**059-001 Oil Tank Assembly
(Replaces older Oil Tank Assembly 04Y-275)**

059-001 OIL TANK ASSY

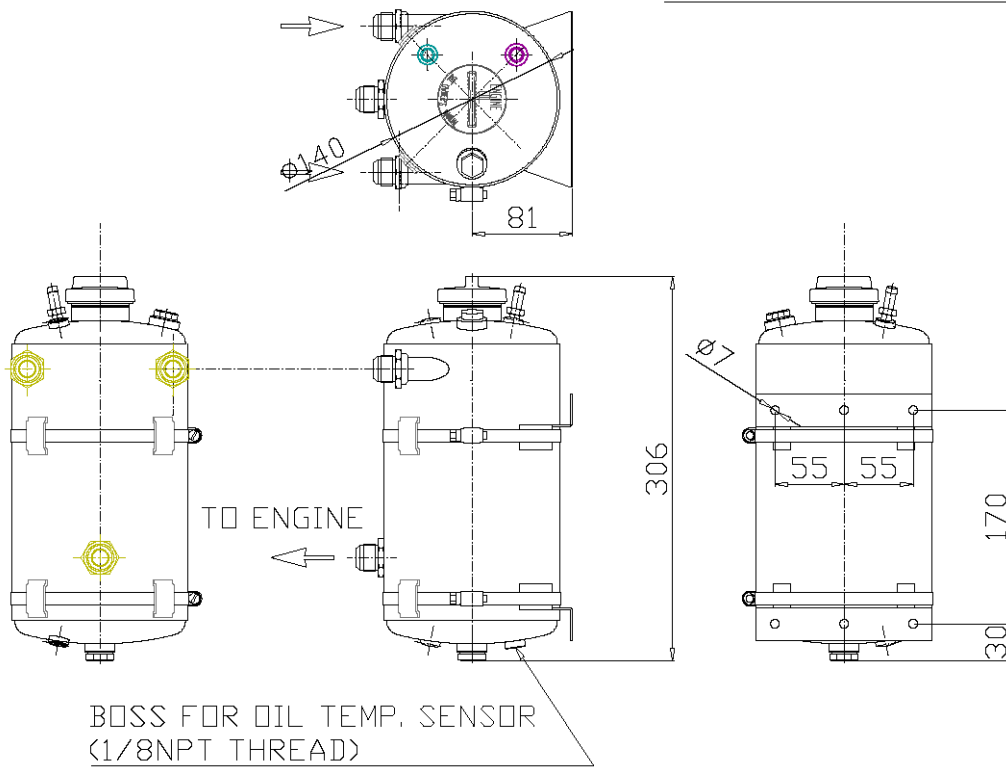
Pictured at the left, 04Y-363 Oil Tank Drain Bolt, 14mm M14 x 1.5mm pitch, 14mm length. Please note; the the depth of boss is about 9mm. If a replacement bolt or plug valve is used, it must be less than 20mm in length.
